Proposed Burlington Quarry Expansion JART COMMENT SUMMARY TABLE – Visual Impact Assessment

NELSON QUARRY VIA (JUNE 2021) - NEC REDLINE Attachment for NEC JART Comments - September 2021

Photo 50: Approx. 2322-2402 2 Side Road. Facing Towards Proposed Southern Extension.

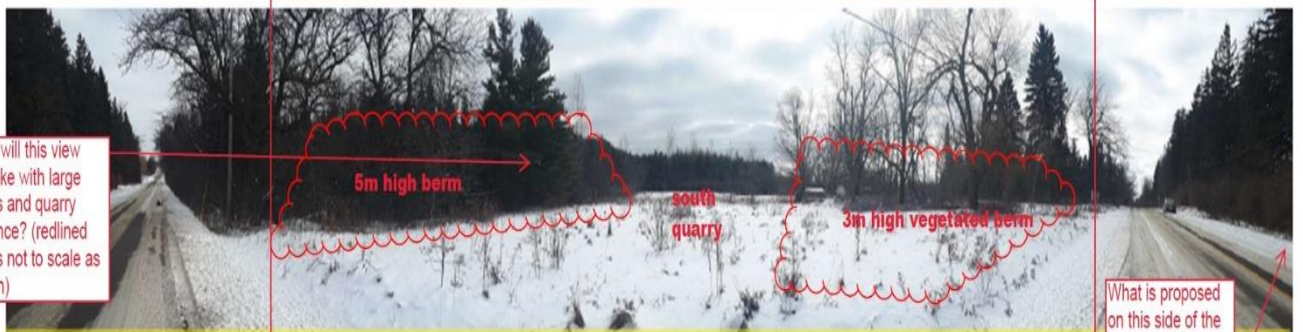
What will this view look like with loss of open view and proposed berming?

What will this view look like with large berms and quarry entrance? (redlined berms not to scale as shown)

What is proposed on this side of the road? Is there a crossing here? Vegetation/berm removal?

These are the views of concern requiring further study. Photo simulations are required. Due to distortion in the panoramas, new base photography may be required for these views to ensure accuracy in the photo simulations.
